Docket No. 52-021  
MHI Ref: UAP-HF-13283

**Subject: MHI's Supplemental Response to US-APWR DCD RAI No. 650-5093 (SRP 03.11)**

Supplemental Response to US-APWR DCD RAI No. 650-5093  
(SRP 03.11)

**QUESTION NO. RAI 03.11-39**

### EQUIPMENT ENVIRONMENTAL & SEISMIC QUALIFICATION PROCESS\*

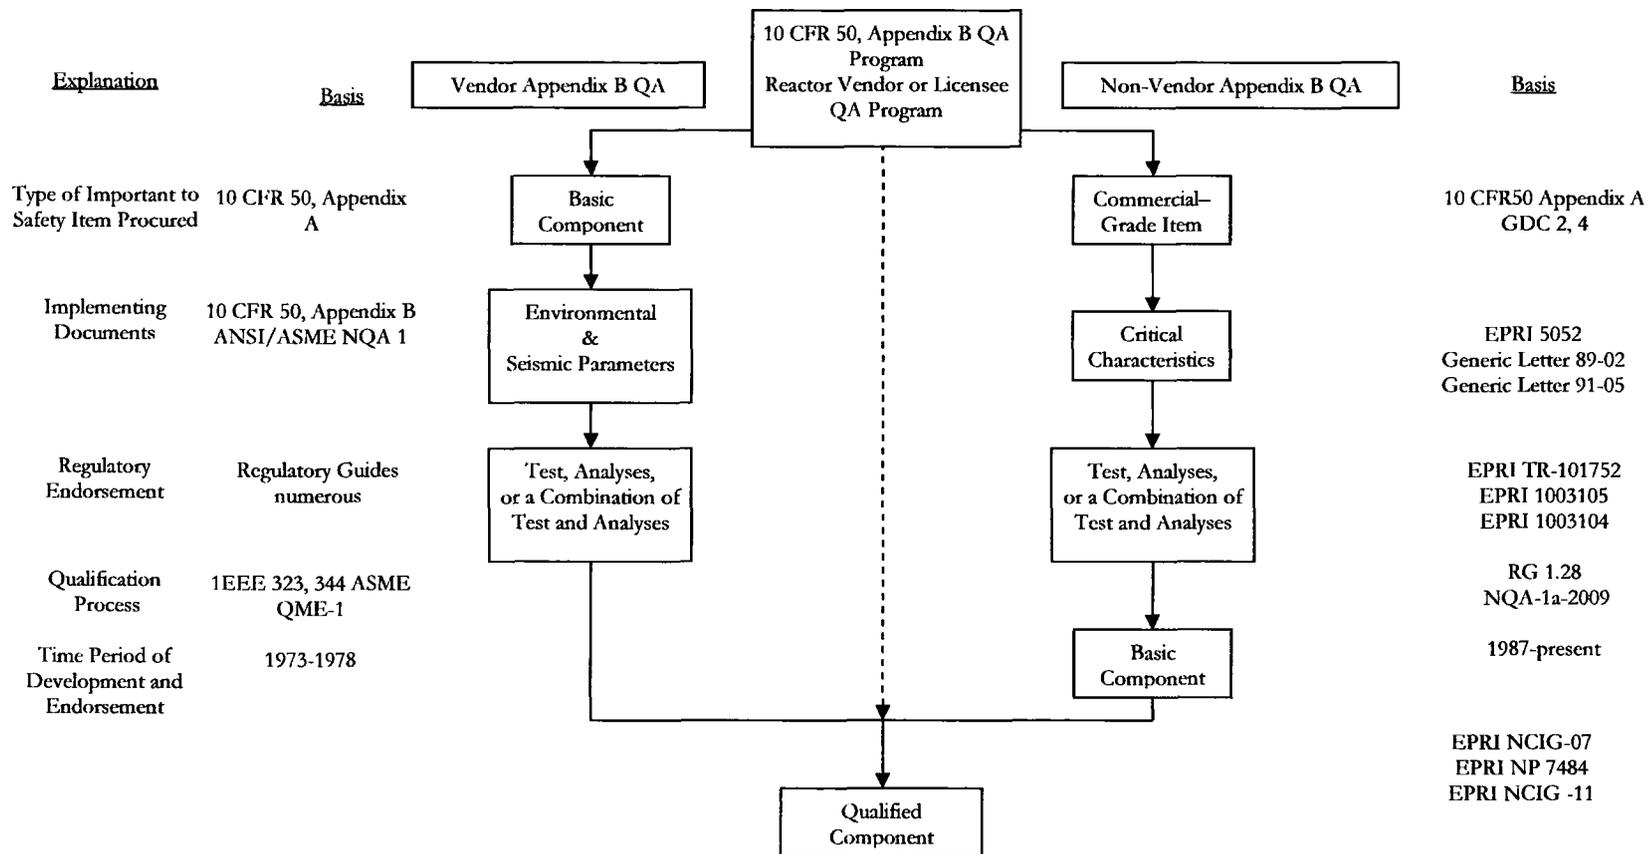
In supplemental response to RAI Question 03.11-19, MHI proposed that Technical Report MUAP-08015, R1, Section 3.1.1, "10 CFR 50.49 Environmental Qualification of Electric Equipment Important to Safety for Nuclear Power Plants," be revised by adding, "An alternate methodology to qualifying equipment in harsh environments is to use commercial dedication methodologies to meet the 10 CFR 50.49 requirements for harsh electrical equipment environment qualification. This qualification method uses commercial grade dedication when the supplier lacks a 10 CFR 50, Appendix B QA program..." This is contrary to the staff position that qualifying equipment in harsh environments can't use commercial dedication methodologies to meet the 10 CFR 50.49 requirements. During the latest teleconference with MHI, the staff cited EPRI TR-102260, "Supplemental Guidance for the Application of EPRI report NP-5652 on the Utilization of Commercial Grade Items," which states that "Equipment Qualification is a part of the design process covered under 10 CFR Part 50, Appendix B, Criterion III which demonstrates either through the testing of a prototype, by engineering analysis of a prototype, or by historical performance demonstration of an item of the same design." On this basis, qualifying equipment in harsh environments is not allowed to use commercial dedication methods to meet the 10 CFR 50.49 requirements. However, EPRI commercial dedication method was conditionally approved by the NRC for satisfying 10 CFR Part 50, Appendix B. Revise Technical Report MUAP-08015, R1 where it is applicable (e.g., Sections 3.1.1, 3.7, Figure 7.1-EQ flow diagram).

This Request for Additional Information (RAI) appears to make the assertion that commercial grade dedication may not be used to qualify important to safety Structures, Systems and Components (SSCs) used in harsh environments. This application of commercial grade dedication for qualifying SSCs is supported by present statutory and regulatory positions. SSCs may be qualified using the conventional approaches used primarily up through the 1980's or by Commercial Grade Dedication (CGD). These two approaches are depicted in

These documents, taken in whole or in part, fully support the NRC's endorsement of the use of CGD as an appropriate methodology for qualifying important to safety and safety-related

SSCs for service in harsh environments. The wording in the MUAP-08015, R1 is consistent with the regulatory guidance cited above. As some references identified in this RAI response provide additional guidance and clarifications regarding CGD, these references and programmatic description enhancements will be added to the next revision of MUAP-08015 to more fully explain the use CGD in the US-APWR Equipment Qualification Program.
